Department of Energy
Washington, DC 20585

On September 8, 2008 the U. S. Department of Energy (DOE) submitted an application for revision of the Model No. ATR FFSC package Certificate of Compliance (CoC) USA/9330/AF-96, Docket No. 71-9330, TAC No. L24248 for transportation of four payload types: ATR fuel elements, MIT fuel elements, MURR fuel elements, and unassembled ATR, MIT and MURR fuel elements plates.

In a letter dated December 1, 2008, the NRC requested additional information (RAIs) in support of this revision. This submittal is the response to the RAIs and also includes the updates to the Safety Analysis Report (SAR), Revision 4.

Advanced Test Reactor Fresh Fuel Shipping Container (ATR FFSC)

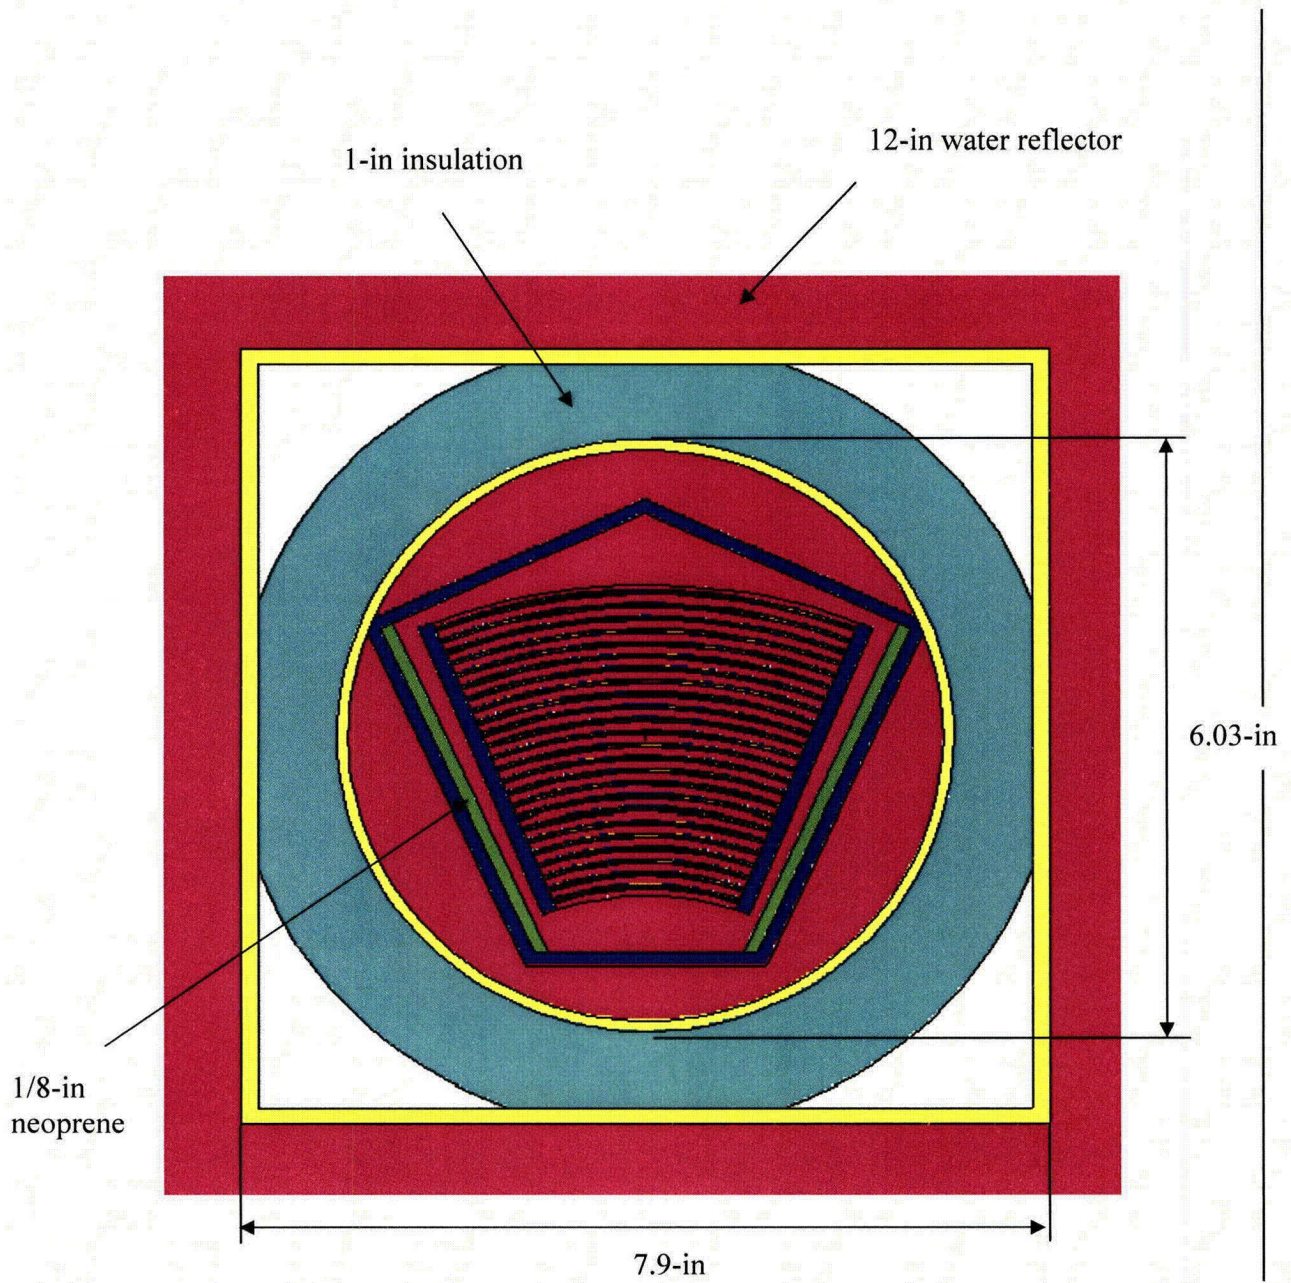
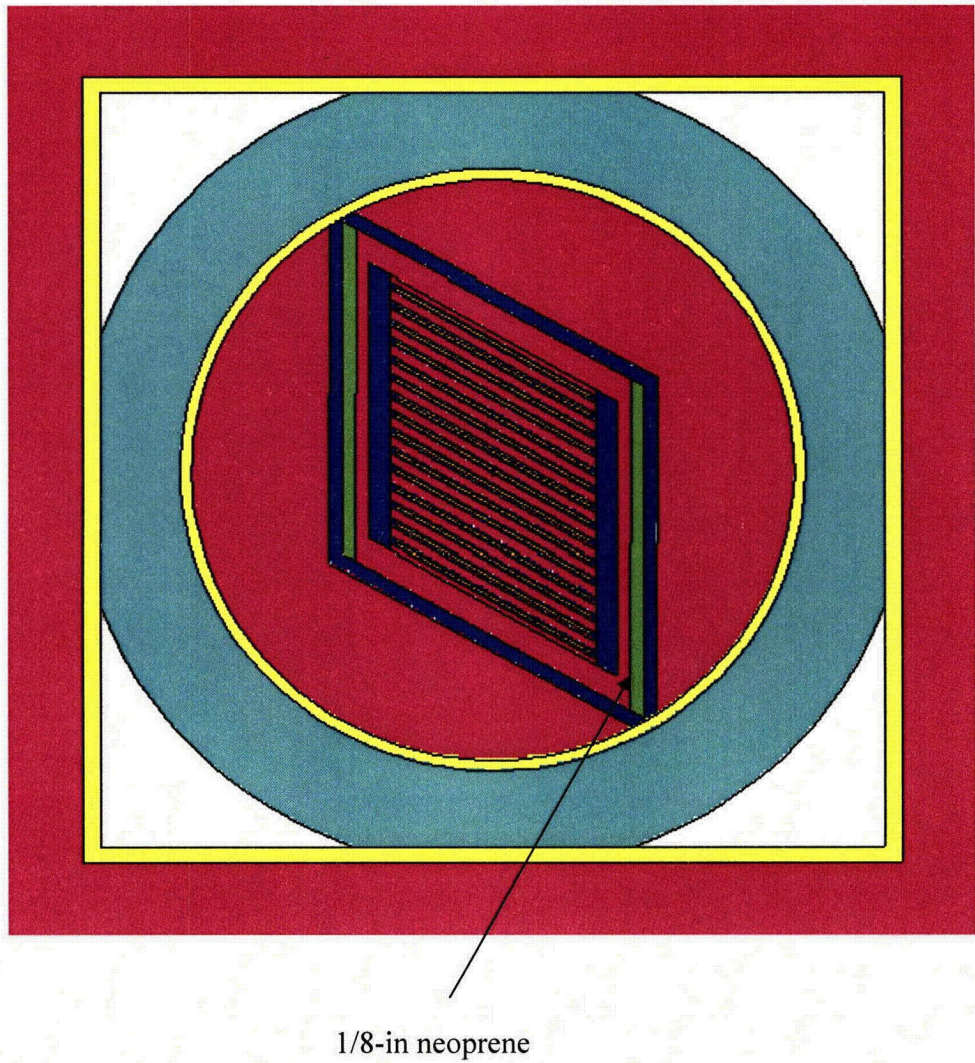
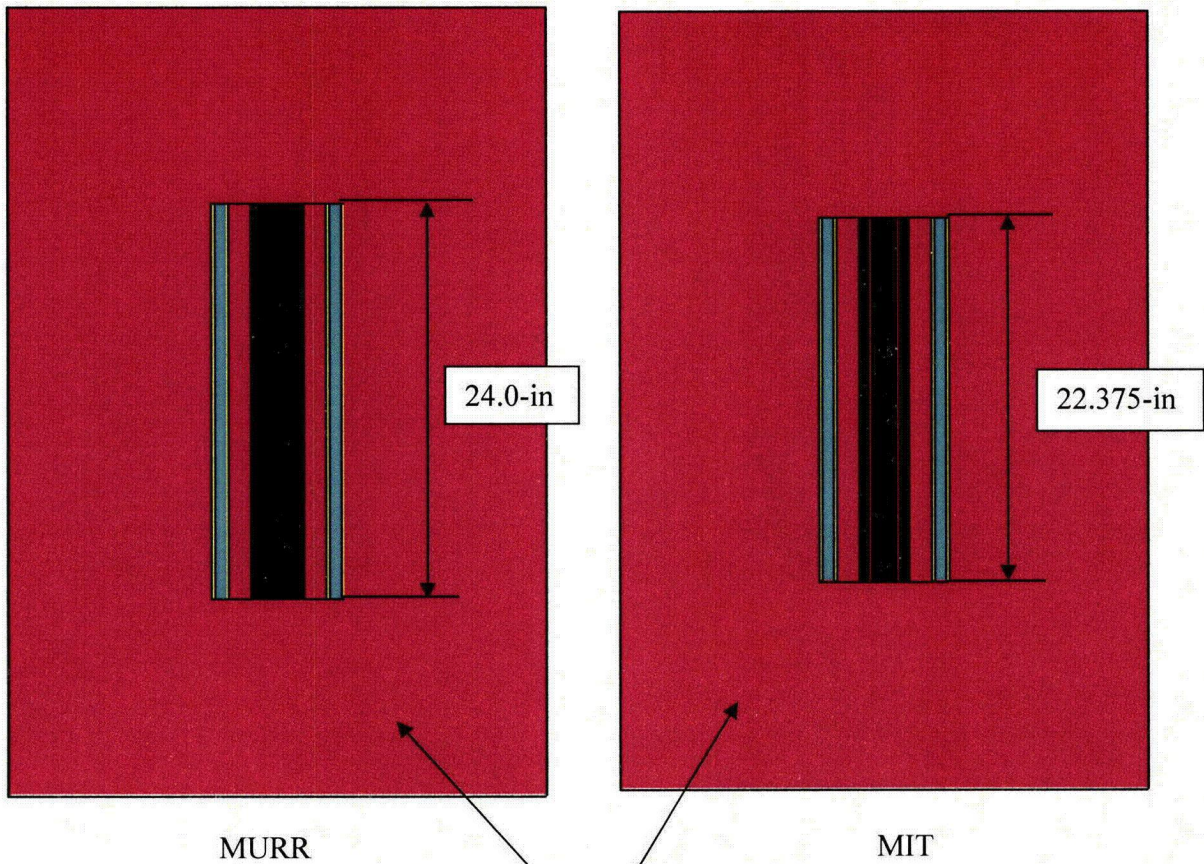
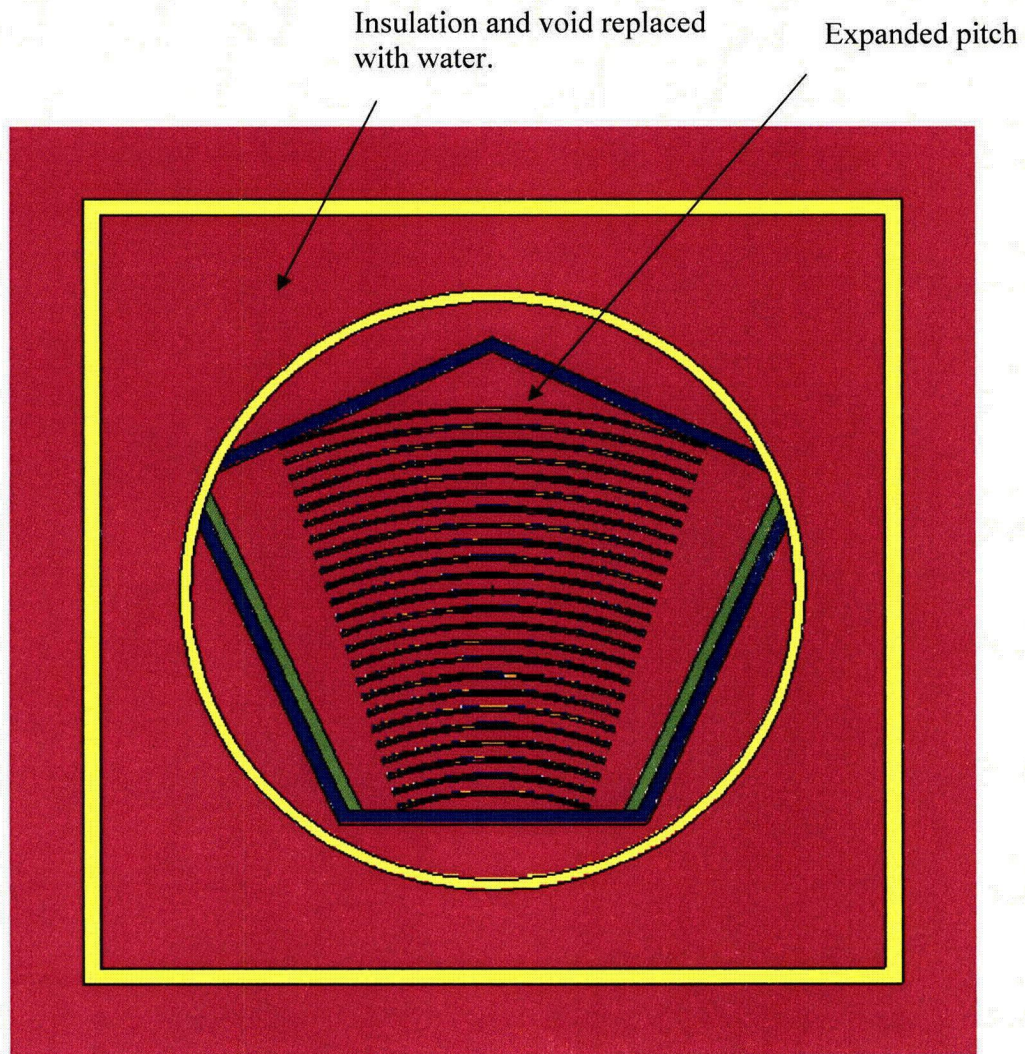
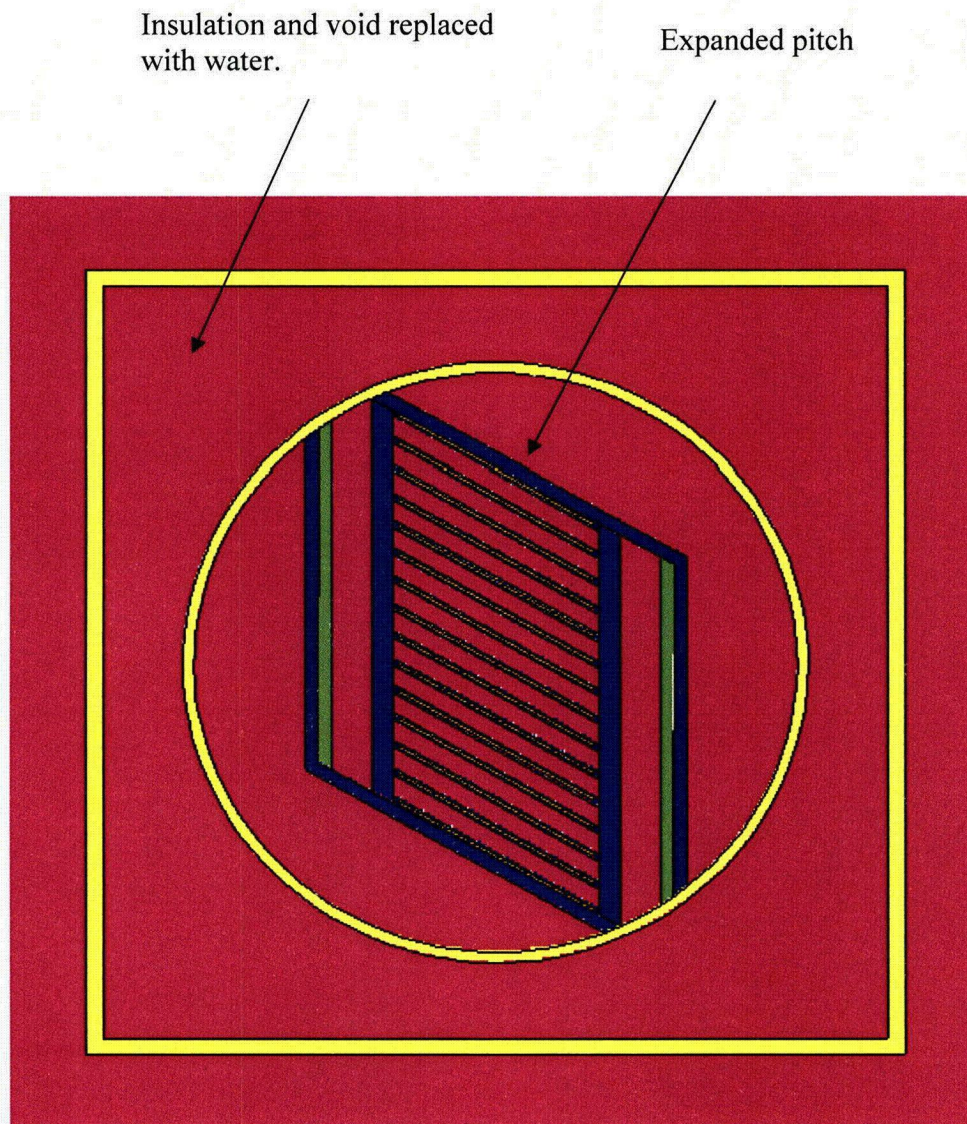
Furthermore, the applicant states in Sections 1.2.1.1.3, 1.2.1.1.4, and 1.2.1.1.5, that the Fuel Handling Enclosures (FHE) "[do] not add strength to the package, or satisfy any safety requirement." Given that the spacers for the MIT and MURR FHEs are necessary to maintain their position within the external packaging, there is a structural function being performed by the spacers and the spacers must be evaluated. If the spacers are not evaluated, then an evaluation must be performed to determine the damage associated with the gap that would exist between the fuel assemblies centered within the outer package and the inner surface of the package end fitting.

elements (see question 2-1). The condition of the MURR and MIT fuel elements used in the HAC analysis should be well justified and be consistent with or conservative versus the fuel element condition resulting from HAC conditions (as determined in the structural evaluation).

Response: The HAC criticality analysis has been revised to consider damage to the MURR and MIT fuel elements by fuel plate pitch expansion to address potential worst case increase in reactivity. The MIT and MURR FHEs restrict postulated fuel element pitch expansion under the HAC conditions. For conservatism in evaluating the HAC conditions, the MIT and MURR FHE postulated damage exceeds the results obtained during testing of the ATR payloads. The spacers securing the MIT and MURR FHE sections are assumed to fail which allows the two sections to spread apart for a worst case reactivity configuration of the fuel elements.

Response: The HAC analysis has been revised to consider damage to the MURR and MIT fuel elements. It is assumed that the fuel element pitch may expand beyond maximum possible extent allowed by the fuel handling enclosures. It is further assumed that the two halves that comprise each fuel handling enclosure have separated, so that a rather large and conservative pitch expansion is utilized.

Because the FHE is credited in the HAC analyses (it was not credited in the original amendment application), for consistency, the NCT analyses for MURR and MIT have been modified to include the FHE
